2.1 Distribution of the Recirculated Draft EIS/EIR

2.2 Comments on the Draft EIS/EIR

2.3 Responses to Comments

2.3.1 USEPA (Comment Letter 1)

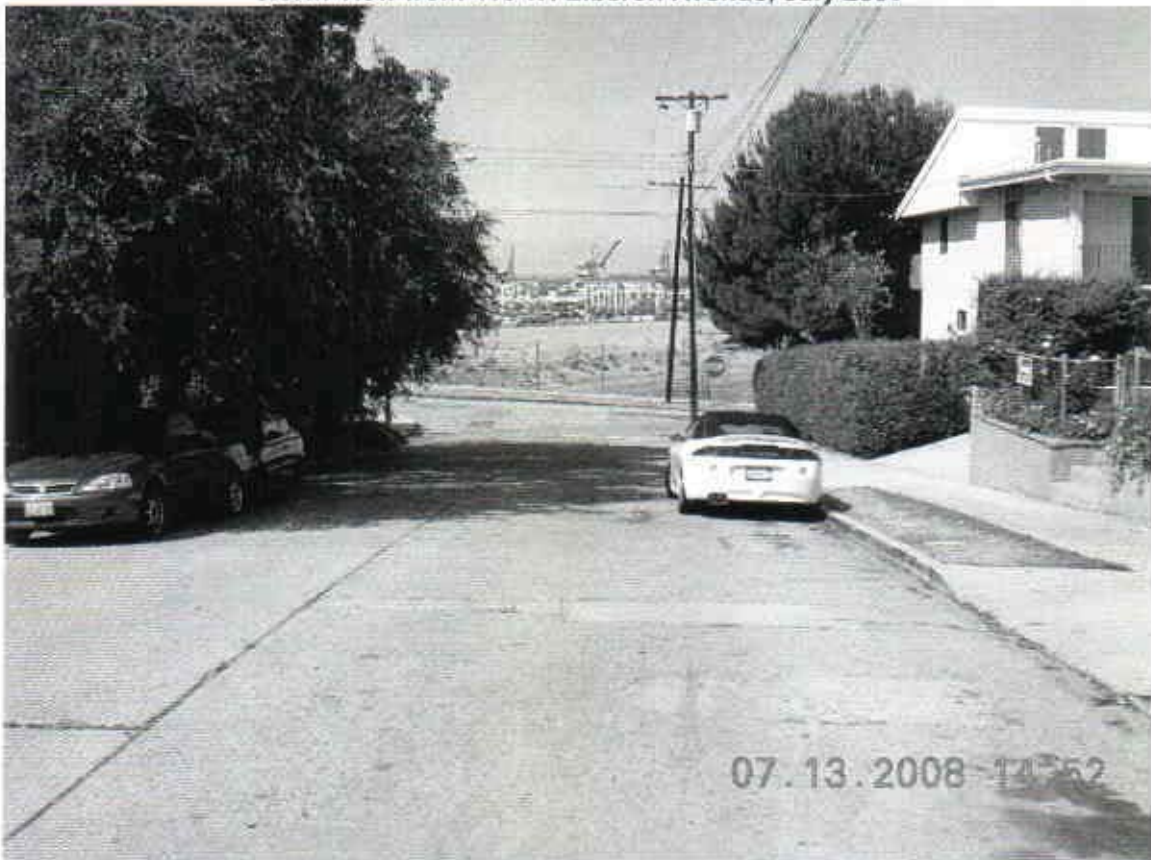
46-10

This aesthetic impact is also referenced under Cumulative Impacts.

The 45 acre fill was created with channel dredgings and fill dirt placed on top to compact and settle the earth. Residents of Knoll Hill and Black Hill formerly had a panoramic waterfront view of the full Southwest Slip and channel. Now it is of this dirt pile, later it will be an overlook of asphalt, cranes, ships, cargo equipment, and stacks of containers and chassis. The project fill was completed in 2003 with the intent of removal of the top portion of earth after two years. It has now been five years and there is still no movement to remove the ugly, weed growing dirt pile. It cannot be understated the aesthetic impact of filling a waterfront view with this horrendous source of visual blight within full view of surrounding residential communities. “Before” and “after” photos of views from the residential neighborhoods in the immediate vicinity are provided below.
